VALUE ENGINEERING STUDY REPORT

LINAC COHERENT LIGHT SOURCE (LCLS) CONVENTIONAL FACILITIES

STANFORD LINEAR ACCELERATOR CENTER
STANFORD UNIVERSITY

March 30-31, 2004

VE STUDY ITEM 1

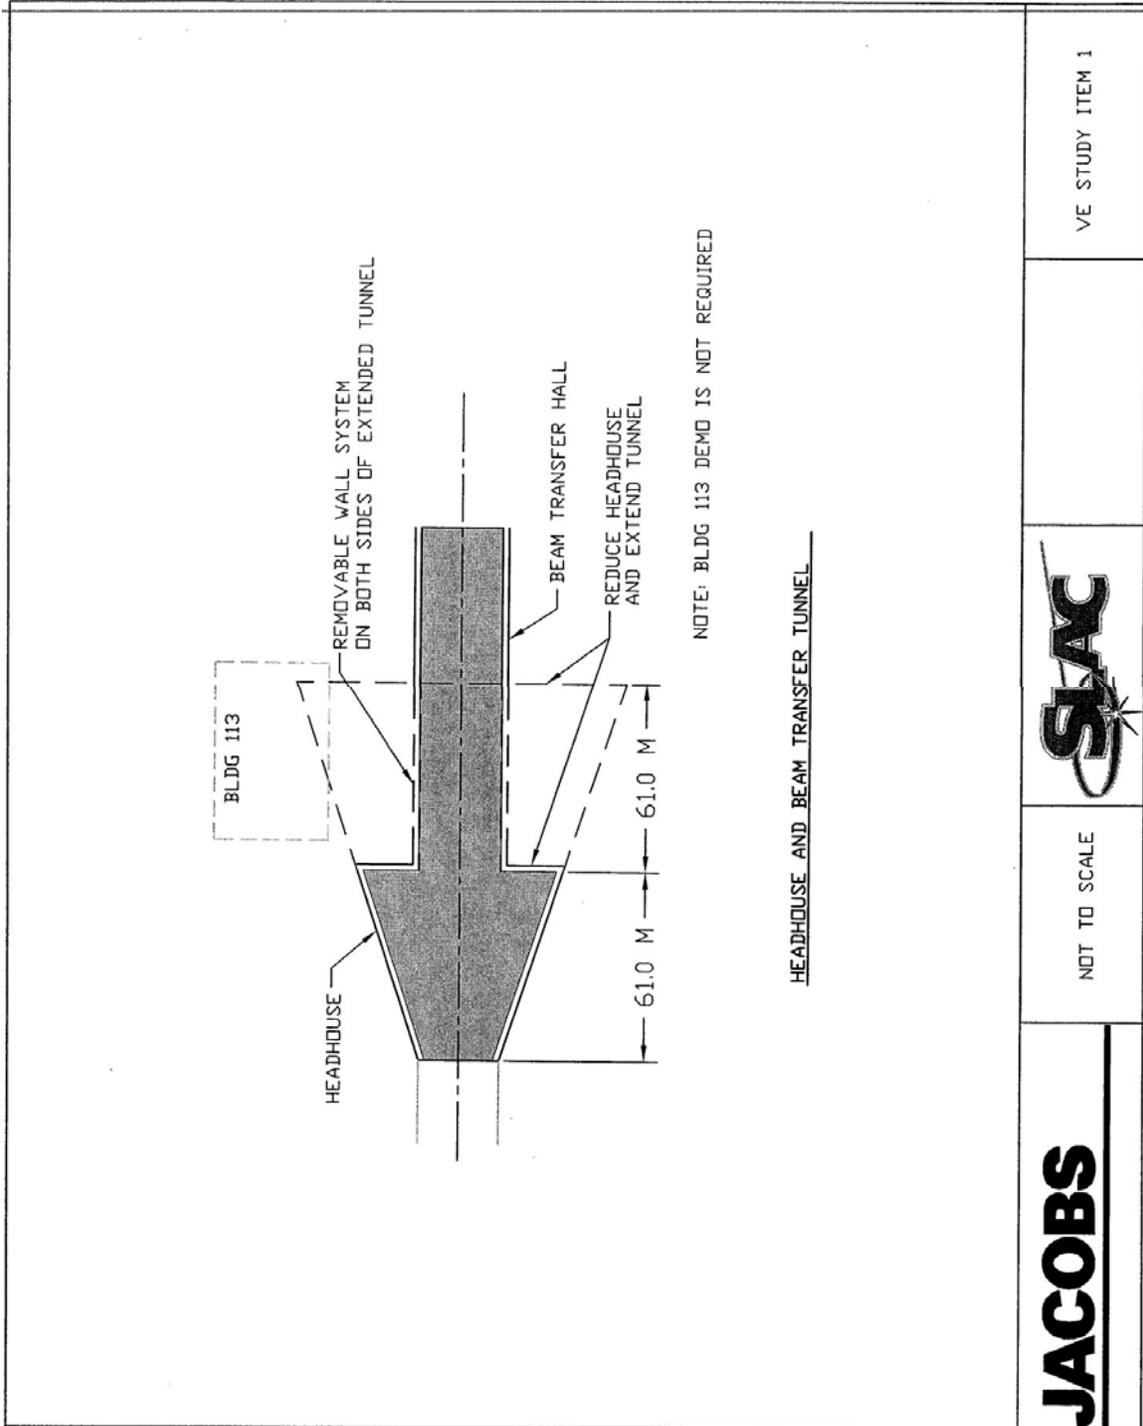
VE1 Recommendation

After evaluation of alternatives by the VE team, a recommendation of a combination of Alternative 2 with Alternative 7 was the selection. This new alternative shortens the Headhouse to 61 meters and extends the BTH Tunnel. The walls in the first 10 meters of the BTH tunnel (from the Headhouse) will be constructed partially with removable blocks to reduce construction cost. This will make construction easier when additional beams are added in the future.

The VE team did not approve of Alternative 8, which had proposed to modify the tunnel cross-section.

Additional Savings is recognized, by allowing Bldg 113 to remain; demolition is estimated at \$100,000.

VE STUDY ITEM 2		NOT TO SCALE	
-----------------	--	--------------	---

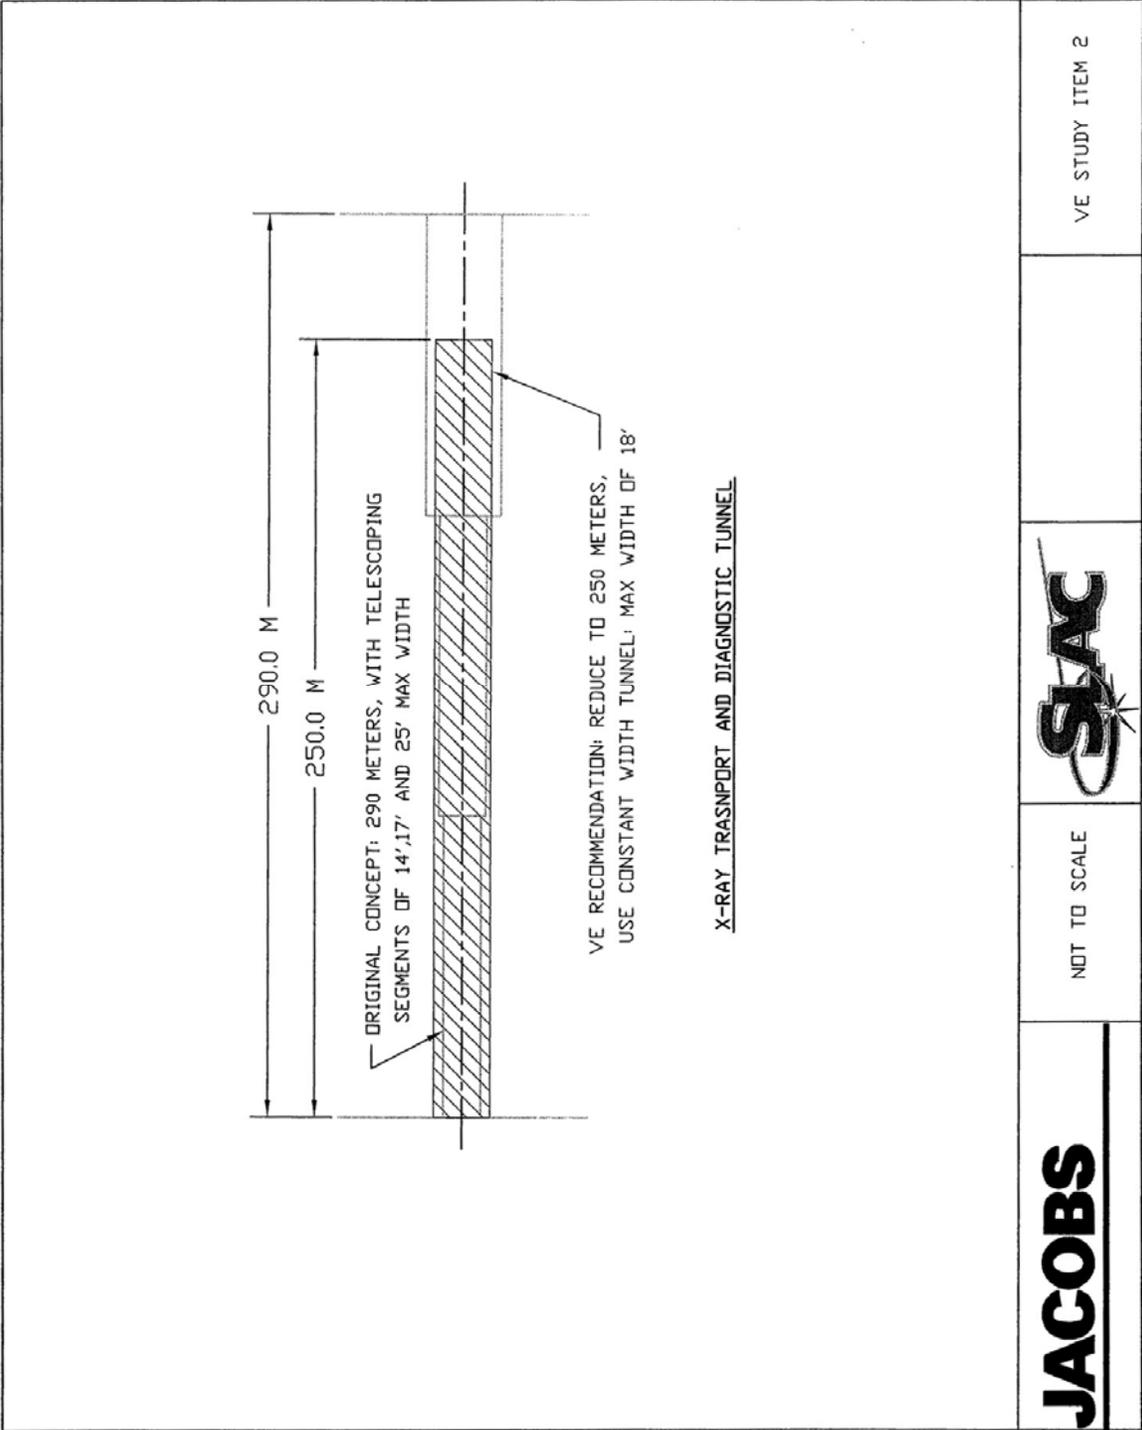
VE2 Recommendation/Discussion

The VE team selected a combination of Alternatives by combining Alternative 2 with Alternative 4. This modification will reduce the length of the X-ray tunnel and use a constant oval shape tunnel with a constant maximum width of 18 feet.

During the evaluation of Alternatives another potential alternative was discussed. This alternative would use micro-tunnels for the beams and one smaller access tunnel, which travels in the east-west direction and has periodic alcoves for maintenance and construction access. However, the VE team then decided this potential alternative would be too difficult for future maintenance, potential problems with leakage and most likely would not result in any cost savings. (See VE Study Item 9 & 11 for additional Studies on the FEH)

Stanford Linear Accelerator Center
 Head House
 VE STUDY ITEM 9: FAR EXPERIMENTAL OFFICES

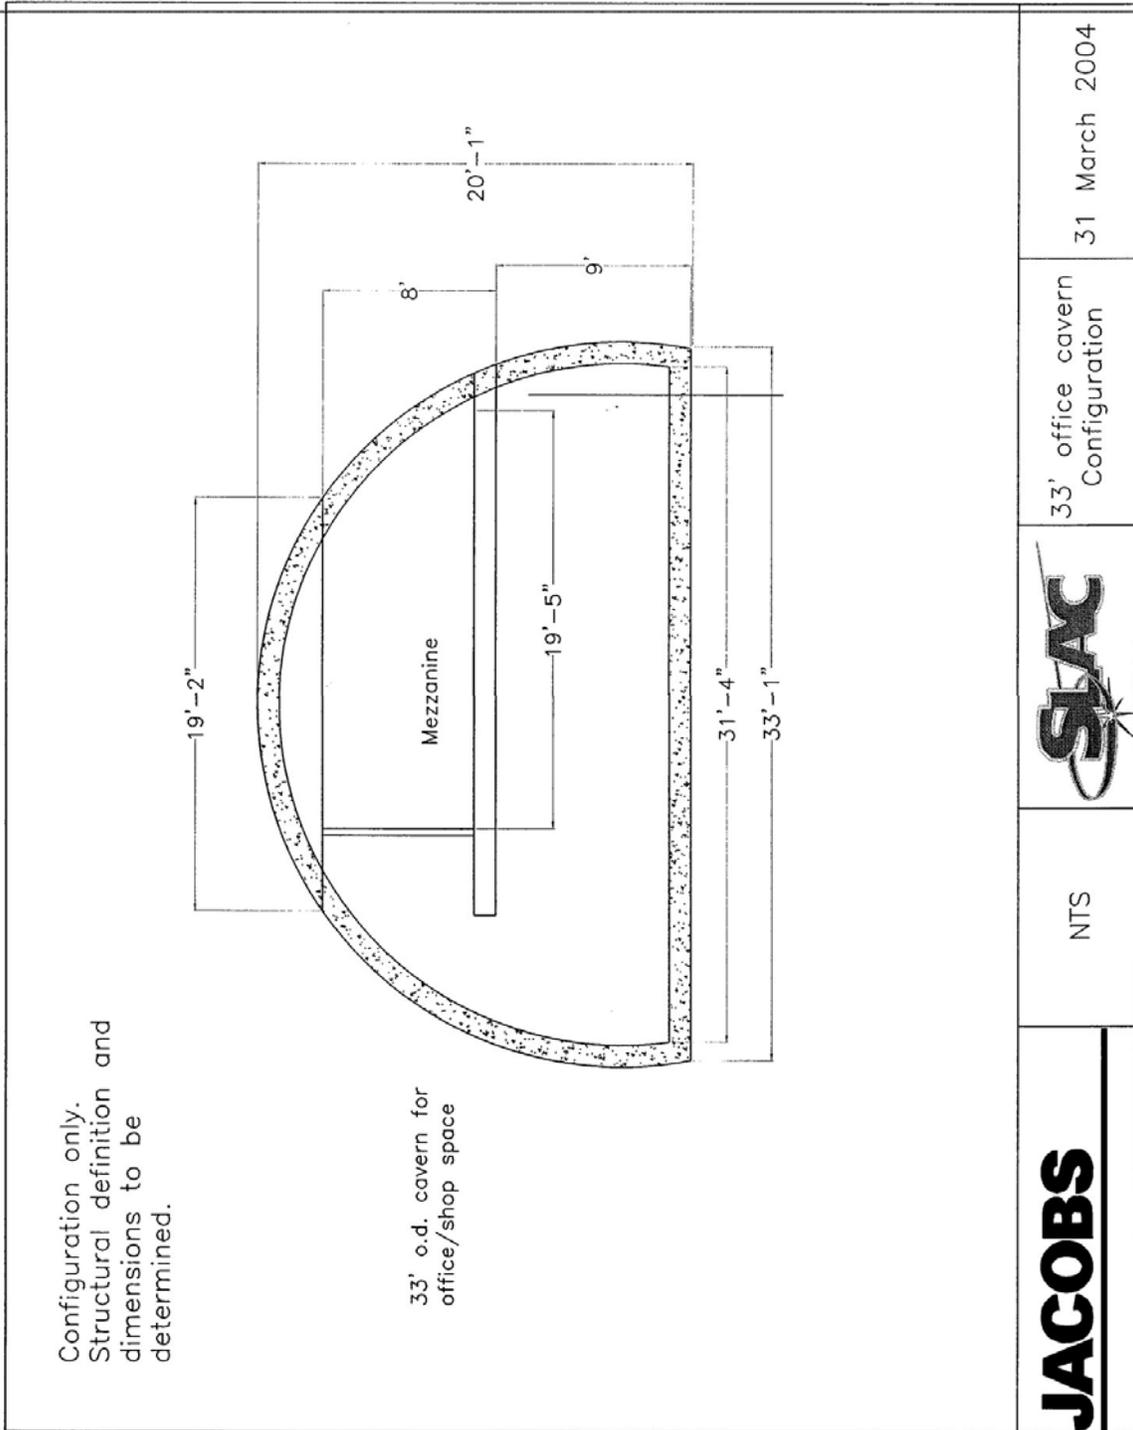
VE9 Recommendation

The VE team recommends Alternative 5, extending the cavern closer to the PEP Ring Road, 112-feet to add labs and mezzanine offices. The interior design of this cavern should be very sensitive to the acoustics, lighting, temperature, and additional comforts for occupants working underground.

With the above grade office and shop facility being relocated, a service road will not be required, avoiding an additional cost of \$500,000.

X-RAY TUNNEL CONFIGURATION

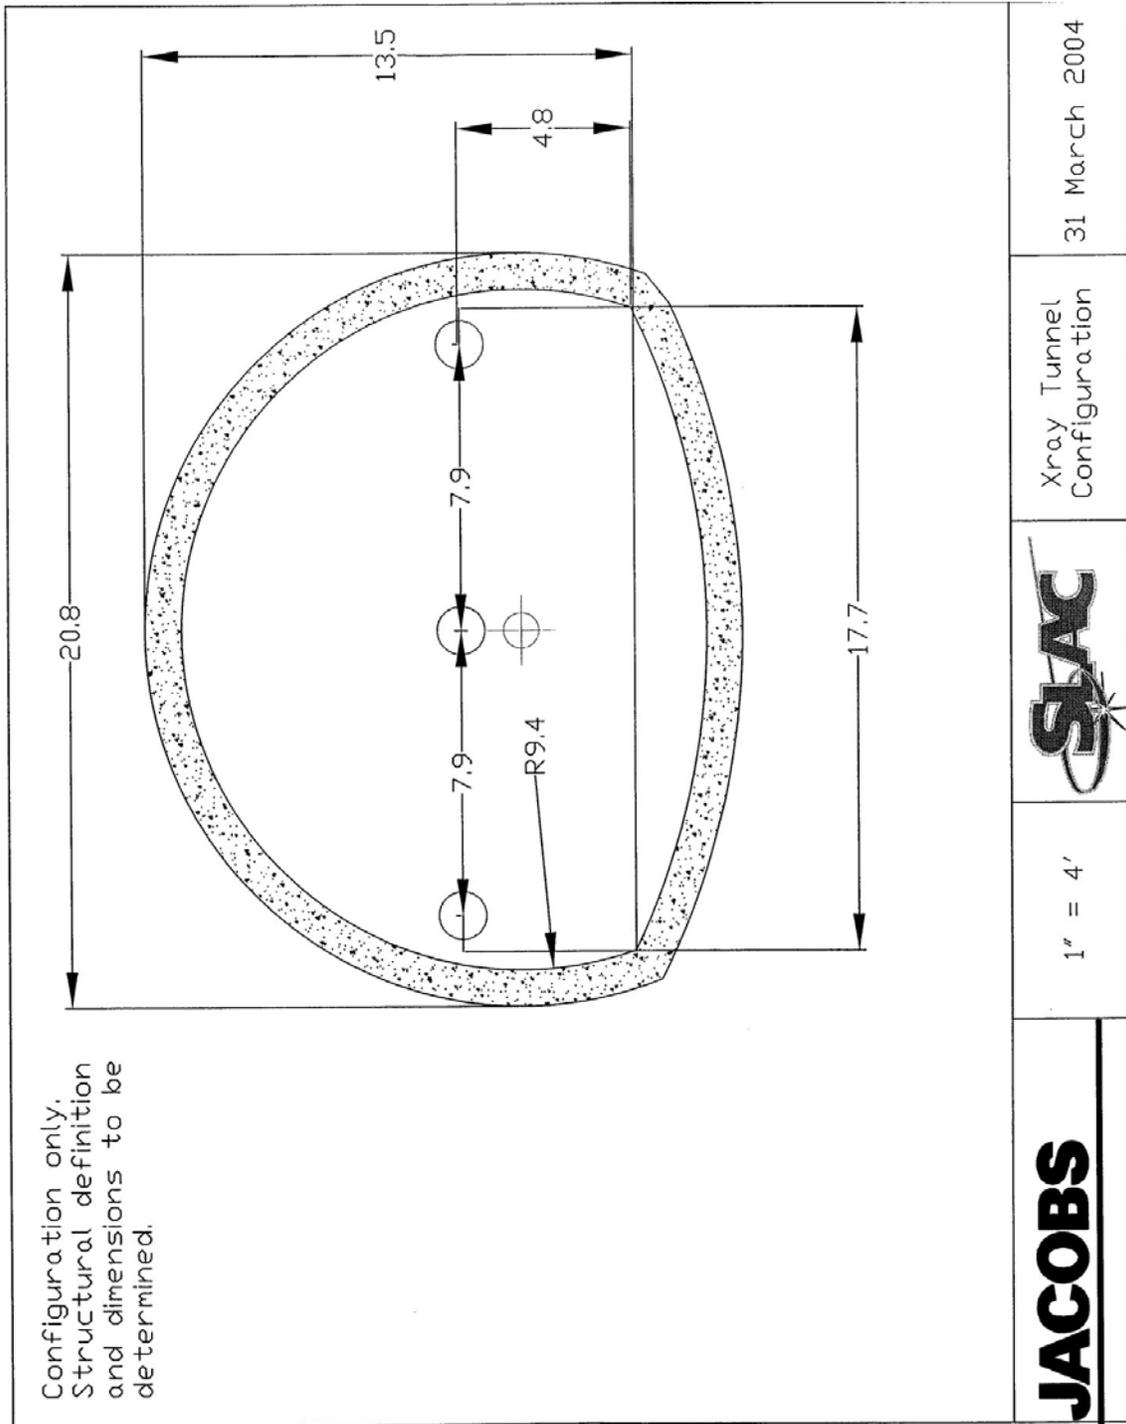
During the VE Study several discussions took place concerning the tunnel layouts for the various components of the LCLS. The VE team has provided the following sketches for the X-Ray Tunnel, Undulator Hall Tunnel and Access Tunnel, per input during the Study.
